Errata: CS5378 Rev B Errata

(Reference the CS5378 data sheet revision DS639F2 dated SEP'08.)

Erratum #1: $\overline{\text{DRDY}}$ Lock Condition

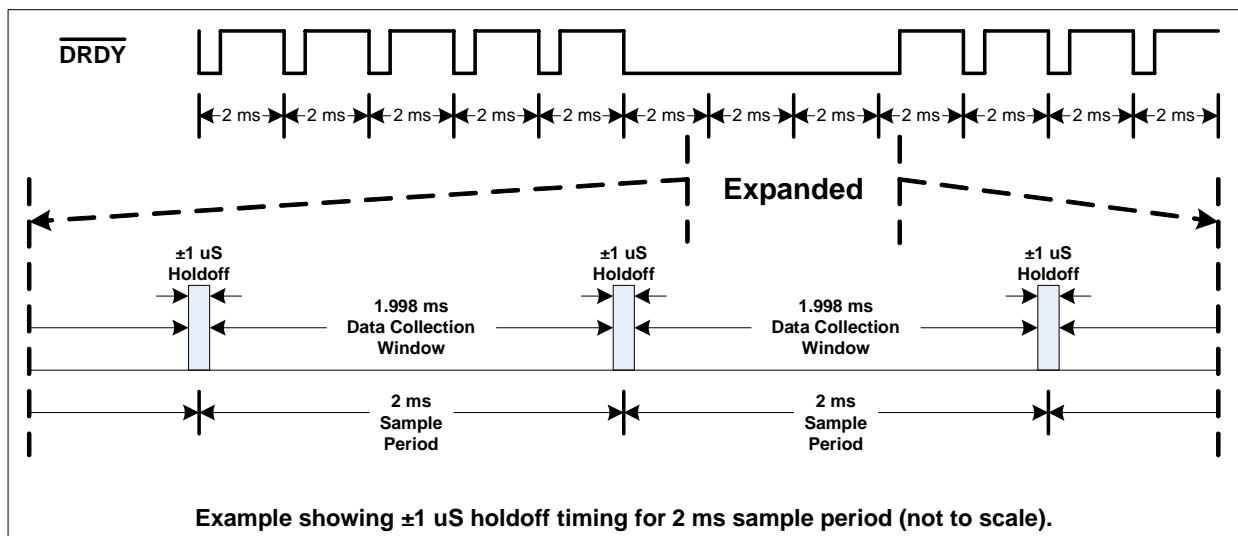
When the CS5378 revB device has data available in the output FIFO it asserts the $\overline{\text{DRDY}}$ pin low to signal the external system to initiate a data collection transaction.

If the external data collection transaction is initiated coincident with a subsequent data word being written into the output FIFO the $\overline{\text{DRDY}}$ signal can permanently lock into a high or low state and no further data transactions can occur.

This erratum is hardware related and requires a hardware reset if it occurs. This behavior can be prevented by always collecting data within one sample period after $\overline{\text{DRDY}}$ goes low so the output FIFO never contains more than one sample.

If the output FIFO must be used due to latency collecting data, carefully time the data collection transaction to avoid an integer sample period timing relative to the initial $\overline{\text{DRDY}}$ assertion. A holdoff of at least ± 1 μs is required around the integer sample period time.
